Access Compliance Report

Public Rights-of-Way

Intersection ID: 16396	Main Street: BEAL_ST	Cross Street: N_WENDOVER_RD	Location: N
ADA ID: 82C50D9A654E	Ramp Type: PerpDiag	Initial Pass/Fail: Fail	Overall Compliance: No
		Severity Score: 12.5

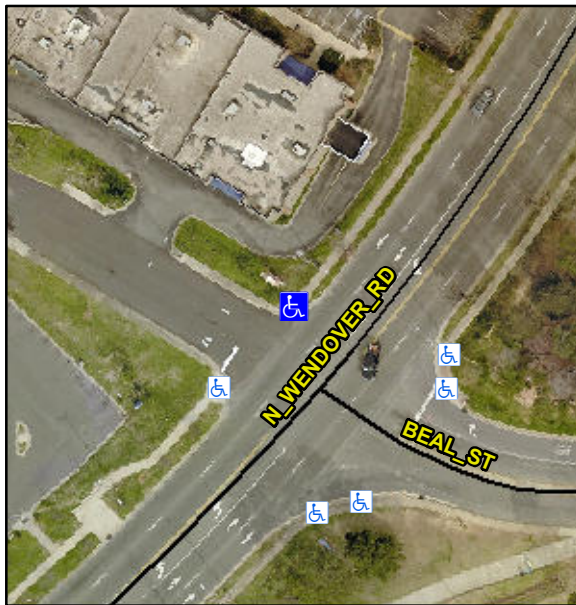
Not Found, R304.2.2

Compliance	Description	Data	Compliance	Description	Data
N/A	Ramp Length (in)	62.0	No	Ramp Slope (%)	8.6
Yes	Ramp Width (in)	48.0	Yes	Ramp XSlope (%)	0.6
N/A	Flare Type LT	N/A	N/A	Flare Type RT	N/A
N/A	Flare Slope LT (%)	N/A	N/A	Flare Slope RT (%)	N/A
N/A	Flare Traversable LT?	N/A	N/A	Flare Traversable RT?	N/A
N/A	Landing Length (in)	N/A	N/A	DWS Provided?	N/A
N/A	Landing Width (in)	N/A	N/A	DWS Contrast?	N/A
N/A	Landing Slope (%)	N/A	N/A	DWS Length (in)	N/A
N/A	Landing X Slope (%)	N/A	N/A	DWS Full Width?	N/A
N/A	Landing Curb? (Y/N)	N/A	N/A	DWS Offset (in)	N/A
N/A	Shared Landing?	N/A			
N/A	Gutter Ponding?	N/A	N/A	Gutter Slope (%)	N/A
N/A	Gutter Lip Ht (in)	2.0	N/A	Gutter X Slope (%)	N/A
N/A	Painted X Walk1?	No	N/A	Painted X Walk2?	No
	X Walk 1 Direction	To SW		X Walk 2 Direction	To SE
N/A	X Walk 1 Width (in)	N/A	N/A	X Walk 2 Width (in)	N/A
	X Walk 1 Slope (%)	0.6		X Walk 2 Slope (%)	2.1
	X Walk 1 X Slope (%)	0.4		X Walk 2 X Slope (%)	1.4

Remove & Replace Curb Ramp With Two New Directional Ramps or Equivalent.
